# UNITED STATES PATENT AND TRADEMARK OFFICE

APPLICATION NO.	FILING DATE	FIRST NAMED INVENTOR	ATTORNEY DOCKET NO.	CONFIRMATION NO.
10/083,975	02/27/2002	Brent S. Nelson	006943.00615	6913
66811	7590	09/18/2007		
BANNER & WITCOFF, LTD. and ATTORNEYS FOR CLIENT NO. 006943 10 SOUTH WACKER DR. SUITE 3000 CHICAGO, IL 60606			EXAMINER	
			WEINSTEIN, STEVEN L	
			ART UNIT	PAPER NUMBER
			1761	
			MAIL DATE	DELIVERY MODE
			09/18/2007	PAPER

<b>Office Action Summary</b>	Application No.	Applicant(s)
	10/083,975	NELSON, BRENT S.
	Examiner	Art Unit
	Steven L. Weinstein	1761

Figure 1. An array of extrusion blow-molded bottles. Courtesy of Johnson Controls, Inc.

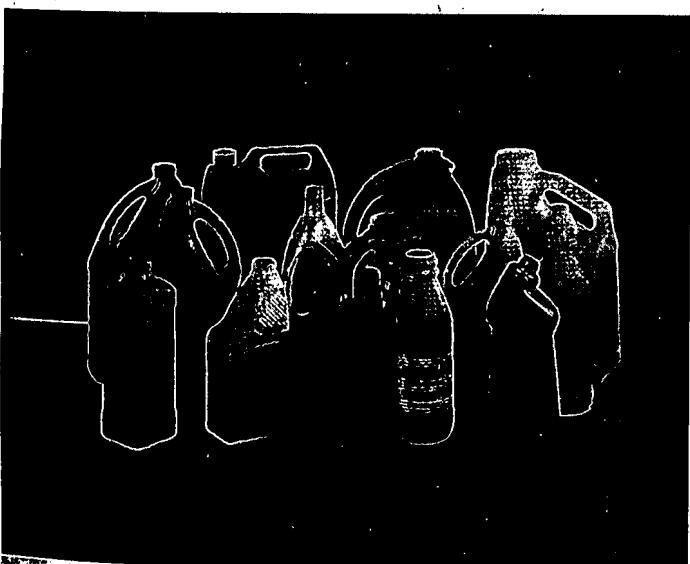
In response to the comments that the Wiley reference did not have a clear photograph, another copy of the photograph is attached to this Office action. This photograph is only being relied to as further evidence that the basic container structure of a blow molded container having a dome like top and a base, and a body portion there between with flat walls and curved corners, and wherein the top and base have a ledge that extends beyond the body portion, is well established in the art. The structure of the blow molded bottle on page 83 is similar to the bottle pictured on page 91, other than, of course, the circular body, rather than the flat body.
